Notice of a Meeting
Dalworthington Gardens Planning and Zoning Commission

PRELIMINARY AND FINAL PLAT
BLISS ADDITION
LOT 19, BLOCK A
BEING 1.001 ACRES OF LAND LOCATED IN THE JOSEPH PIERCE SURVEY, ABSTRACT NO. 1253 AN ADDITION TO THE CITY OF DALWORTHINGTON GARDENS, TARRANT COUNTY, TEXAS

RE: First Preliminary & Final Plat Submittal Review
3815 Kelly Perkins
KHA No. 068302514

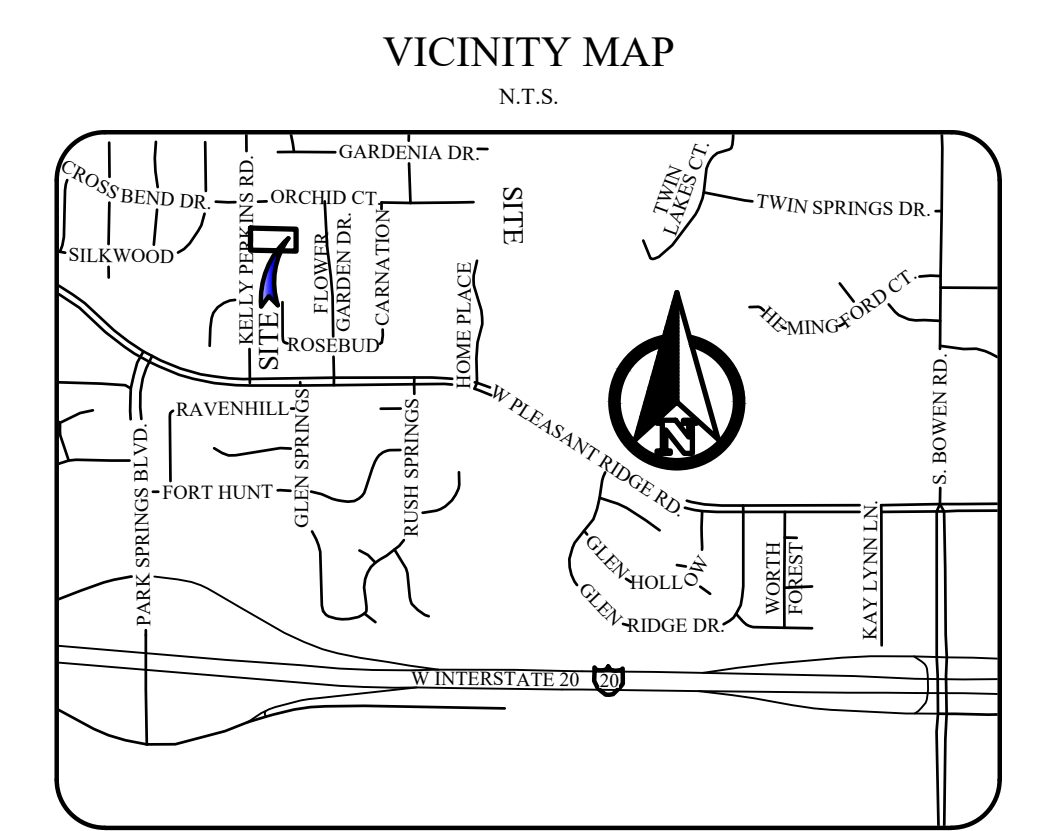
- 1) Provide the names of all adjacent property owners and match descriptions with the Appraisal District records.
- 2) Show and label all building setbacks per section 14.02.171 or the Code of Ordinances.

- 3) Show and label all existing utilities on and adjacent to the property and label the line sizes.
- 4) Note benchmarks used.
- 5) Any major proposed changes in topography shall be shown by labeled contour lines.

- 6) Provide a preliminary water and sewer exhibit that shows how water and sewer service will be provided to the lot.
- 7) Label the lot acreage minus the ROW dedication.

- 8) Provide a preliminary drainage plan to show how the property will drain.
- 9) Label the right of way width for all roadways.
- 10) Include the certifications and statements listed in section 10.02.123/2 and verify that they match the ordinance exactly. These certifications and statements can be found as attachments to Chapter 10 of the online Code of Ordinances.
